ADDENDUM NO. 8

Reference: Holland Centennial Commons
Dixie State College – St. George, Utah
DFCM Project No. 06297640

ADDENDUM #8

PROJECT:	**Dixie State College of Utah** **Holland Centennial Commons**	**ARCHITECT'S PROJECT NO:**	09625
		No. Pages:	38 pages
OWNER:	Dixie State College	**DATE:**	January 6, 2011
ARCHITECT:	VCBO Architecture	**GENERAL CONTRACTOR:**	
SUBMITTAL DATE:	January 19, 2011	**SUBMITTAL TIME:**	12:00pm

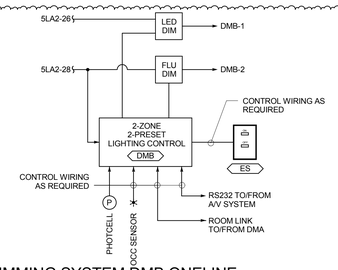
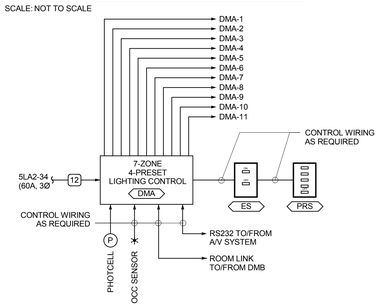
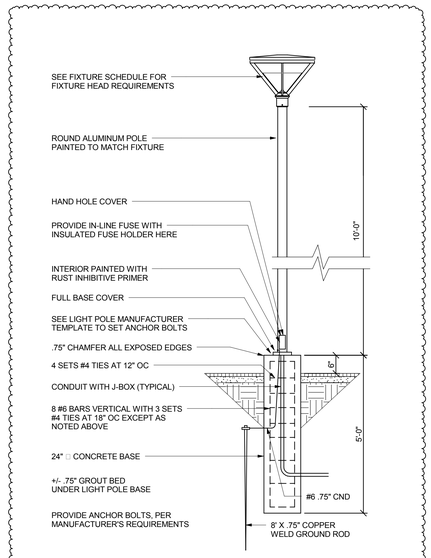
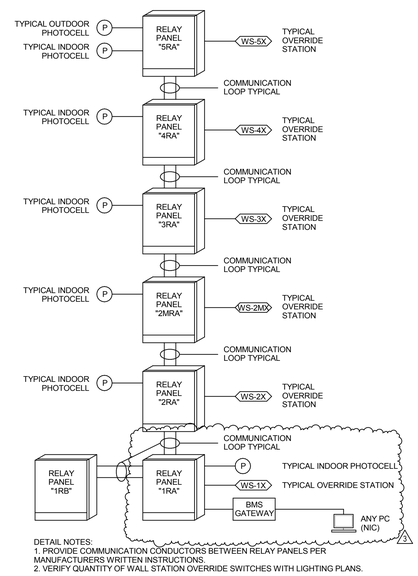
1. Refer to attached full size sheet EL501 for changes described below.
2. Add walkway pole base detail.
3. Add BMS gateway to lighting relay control schematic.
4. Add details for entry station ES, preset station PRS, dimmer station DMA and dimmer station DMB.
5. Add oneline diagrams for dimming systems DMA and DMB.
